**Addendum 1**  
**Solicitation 24-99402**  
**2024 Hermantown Hydraulics Demolition**

**ADDENDUM NO. 1**  
March 8, 2024

**2024 HERMANTOWN HYDRAULICS DEMOLITION**  
**CITY OF DULUTH: 24-4402**  
**DULUTH INTERNATIONAL AIRPORT**  
**DULUTH, MN**

This addendum consists of 1 page and Drawing Nos. G1.02 and C3.00.

SHEET TITLE  
OTHER SAFETY  
NOTES & STATEMENT  
OF ESTIMATED  
QUANTITIES

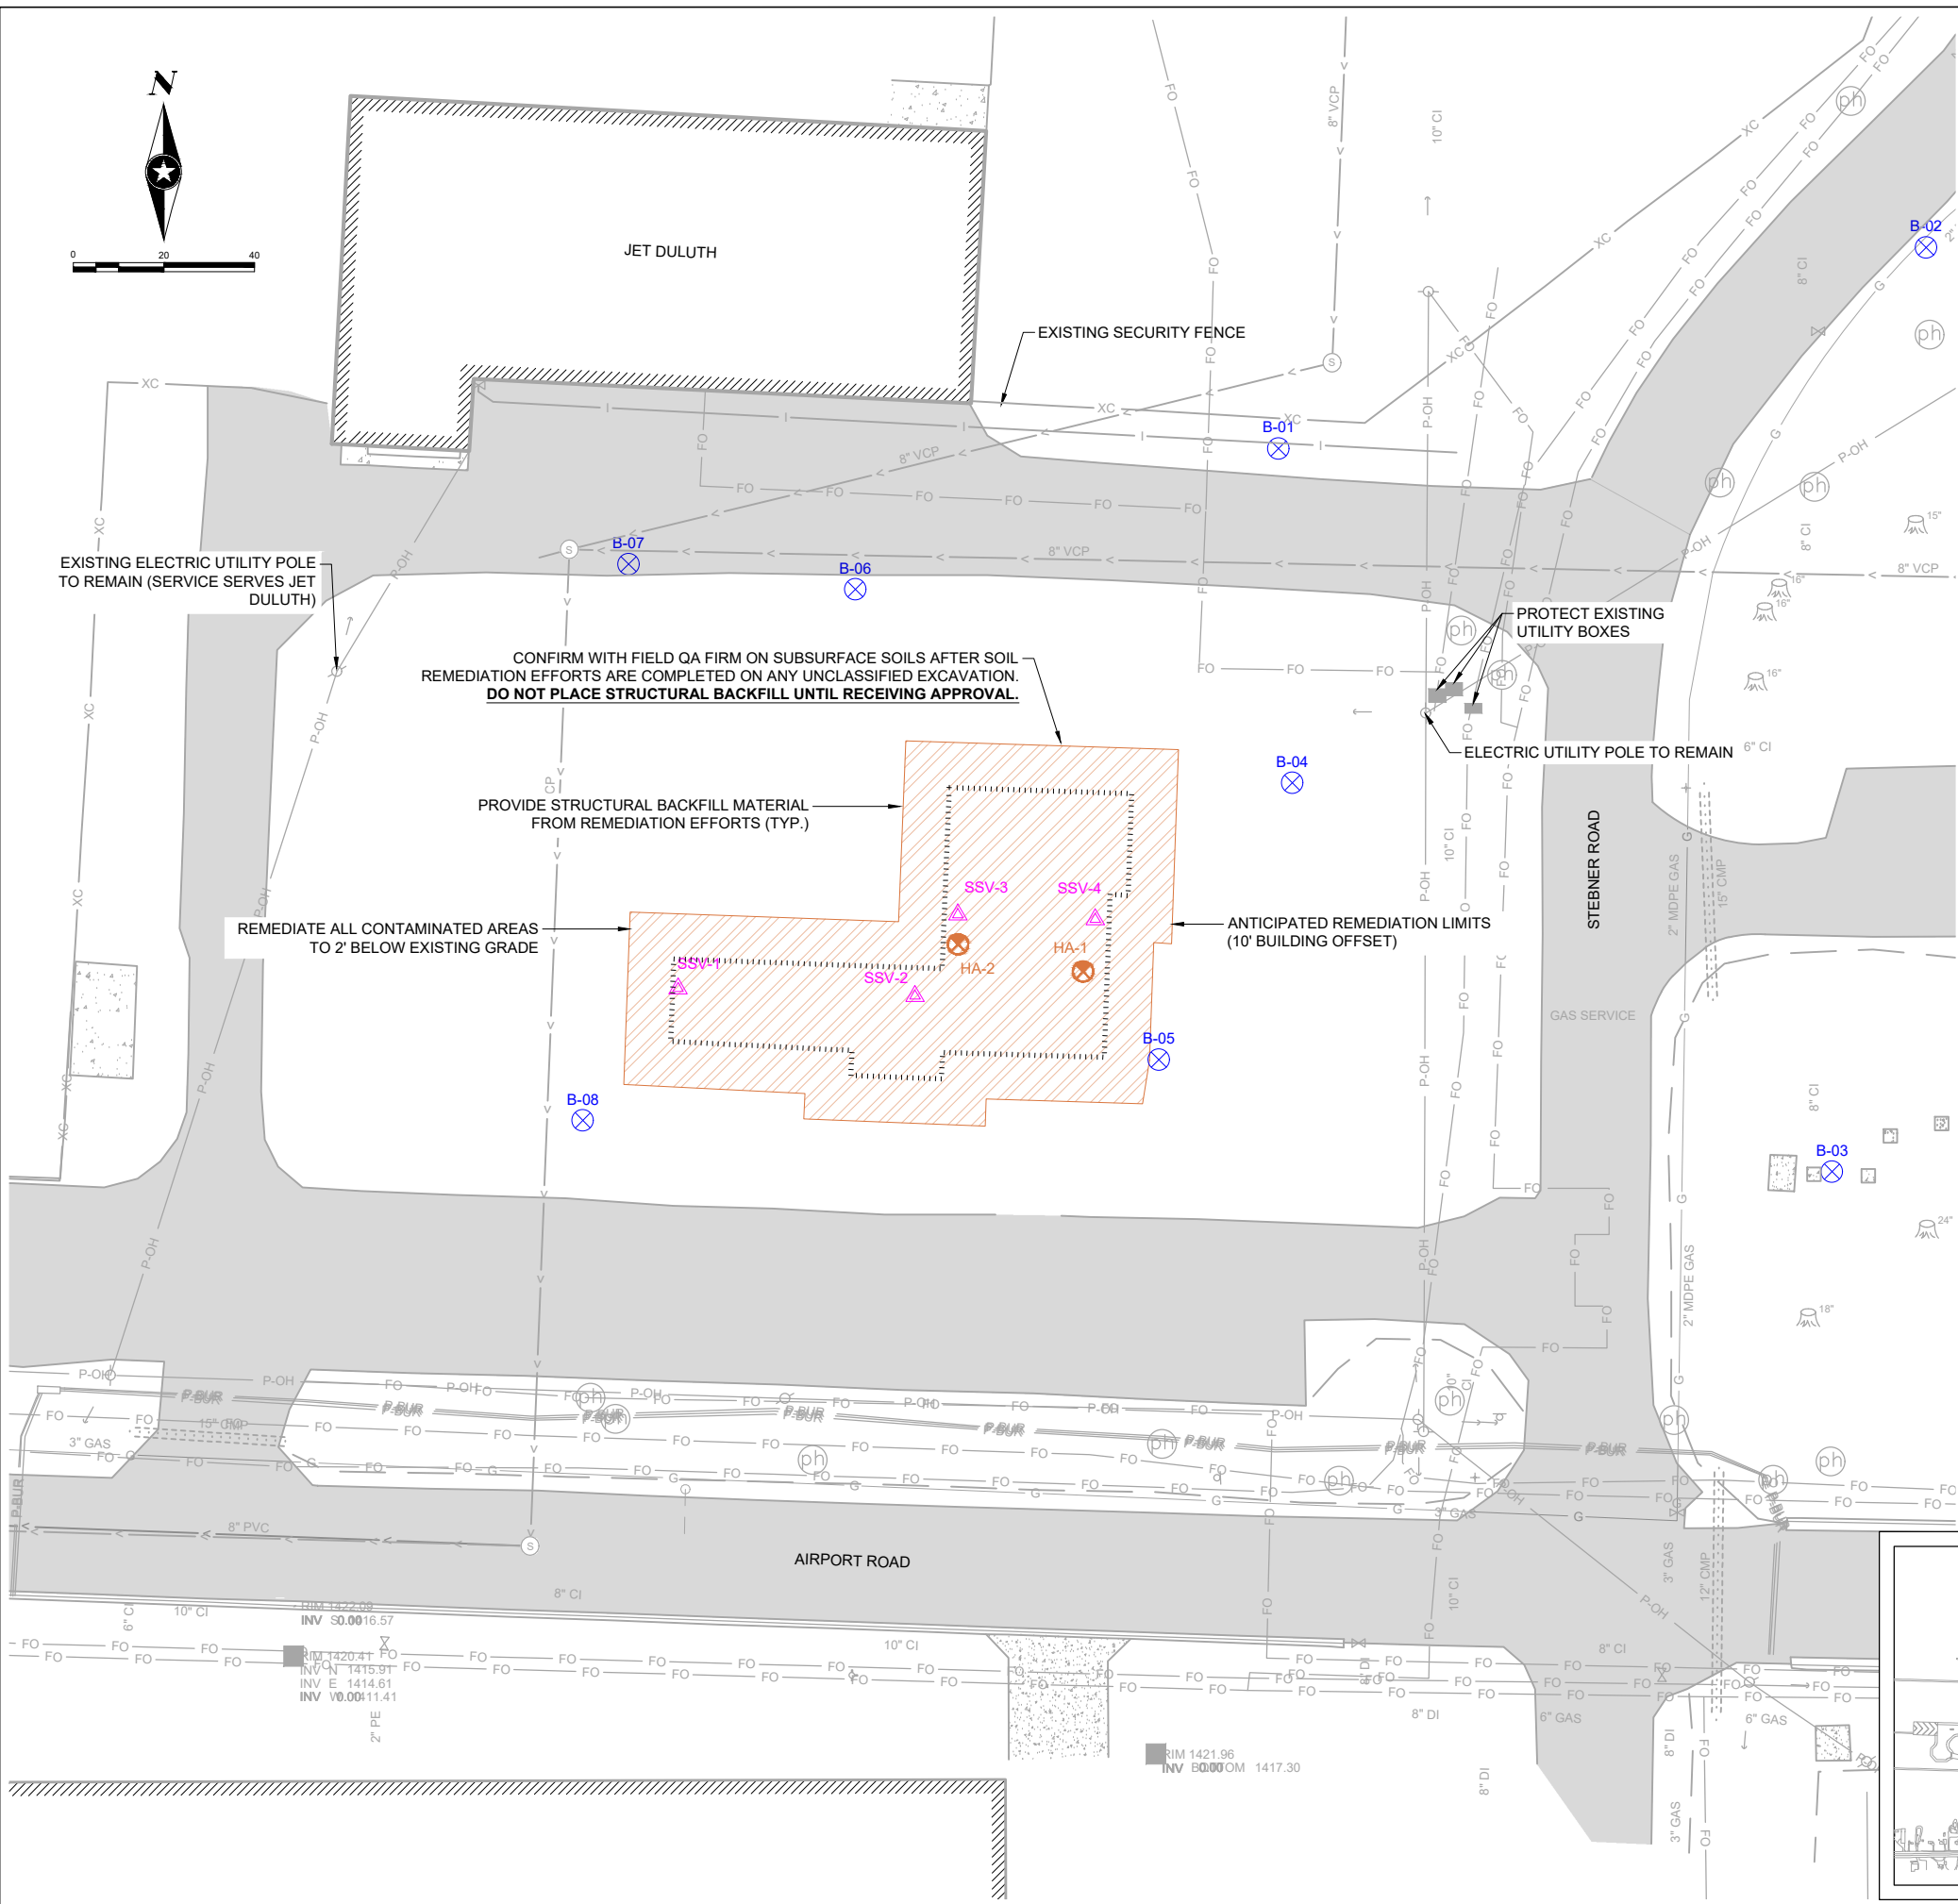
2. Drawing G1.02 – Other Safety Notes & Statement of Estimated Quantities, DELETE in its entirety and REPLACE with the attached revised drawing.
  - Updated SEQ
3. Drawing C3.00 – Soil Remediation Plan, DELETE in its entirety and REPLACE with the attached revised drawing.
  - Update General Notes
